## **Access Compliance Report Public Rights-of-Way** (Curb Ramps)

Intersection ID: 52450 Main Street: TRANQUIL\_OAK\_PL **Cross Street: MOSS LN** Location: SW ADA ID: 09C09F5F9866 Ramp Type: BlendTrans1 Initial Pass/Fail: Fail **Overall Compliance: No Severity Score:** 1.25

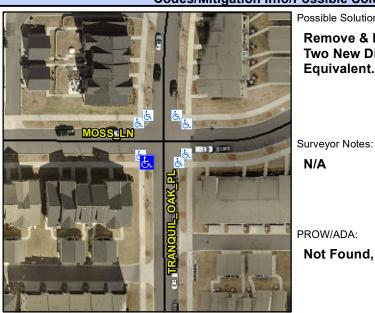
TRANQUIL OAK PL Street 1 Name StopSign Stop Condition-Street 1 Street 2 Name N/A Stop Condition-Street 2 N/A Remove & Replace Curb Ramp With **Two New Directional Ramps or** Equivalent.

Not Found, R304.5.3
